Service Bulletin

Bulletin No.: PIC5321A

Subject: Various Electrical Problems

Models: 2010 - 2011 Cadillac DTS

2390750

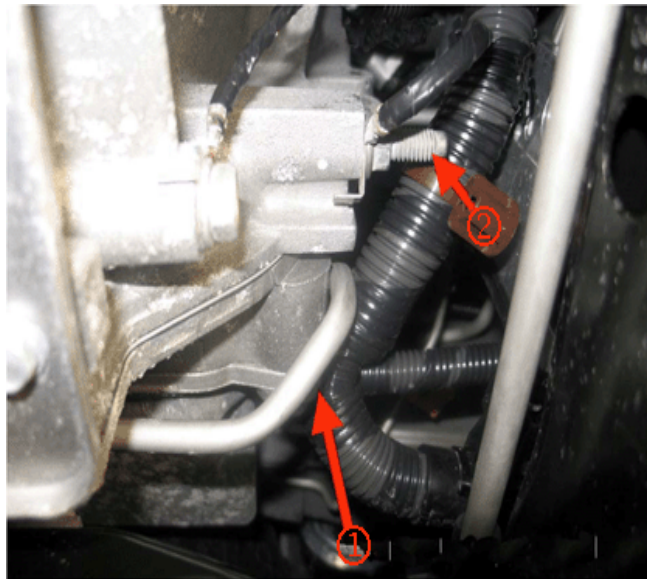
In rare cases a customer may comment on the SES light on, "Service Brake System", "Service Power Steering" message on the DIC, and/or power door locks cycling accompanied by a possible DTC C0450. The brake and steering systems will continue to function as designed.

There may be an engine harness rubbing through on the lower front part of the transmission. The concern may not be limited to these conditions alone since this is a main wiring harness.

If harness is pinched (1), reroute harness, inspect for damaged wiring and repair as necessary.

Install harness clip on transmission stud as necessary (2).
